Access Compliance Report

Public Rights-of-Way

Intersection ID: 13872	Main Street: S_TRYON_ST	Cross Street: W_WORTHINGTON_AV	Location: SW
ADA ID: A57BE60DC3C8	Ramp Type: Perp	Initial Pass/Fail: Fail	Overall Compliance: No
Severity Score: 25			
Codes/Mitigation Info/Possible Solution		Field Measurements/Component Compliance

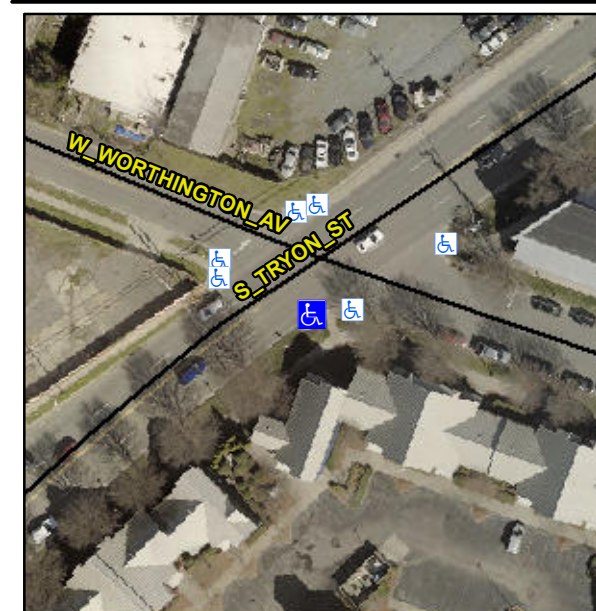
Not Found, R304.2.2, R304.5.3

Compliance	Description	Data	Compliance	Description	Data
N/A	Ramp Length (in)	60.0	No	Ramp Slope (%)	10.0
Yes	Ramp Width (in)	48.0	No	Ramp XSlope (%)	6.4
N/A	Flare Type LT	N/A	N/A	Flare Type RT	N/A
N/A	Flare Slope LT (%)	N/A	N/A	Flare Slope RT (%)	N/A
N/A	Flare Traversable LT?	N/A	N/A	Flare Traversable RT?	N/A
N/A	Landing Length (in)	N/A	N/A	DWS Provided?	N/A
N/A	Landing Width (in)	N/A	N/A	DWS Contrast?	N/A
N/A	Landing Slope (%)	N/A	N/A	DWS Length (in)	N/A
N/A	Landing X Slope (%)	N/A	N/A	DWS Full Width?	N/A
N/A	Landing Curb? (Y/N)	N/A	N/A	DWS Offset (in)	N/A
N/A	Shared Landing?	N/A			
N/A	Gutter Ponding?	N/A	N/A	Gutter Slope (%)	N/A
N/A	Gutter Lip Ht (in)	N/A	N/A	Gutter X Slope (%)	N/A
N/A	Painted X Walk1?	No	N/A	Painted X Walk2?	N/A
	X Walk 1 Direction	To NW		X Walk 2 Direction	N/A
N/A	X Walk 1 Width (in)	N/A	N/A	X Walk 2 Width (in)	N/A
	X Walk 1 Slope (%)	0.7		X Walk 2 Slope (%)	N/A
	X Walk 1 X Slope (%)	5.7		X Walk 2 X Slope (%)	N/A

Remove & Replace Entire Ramp.
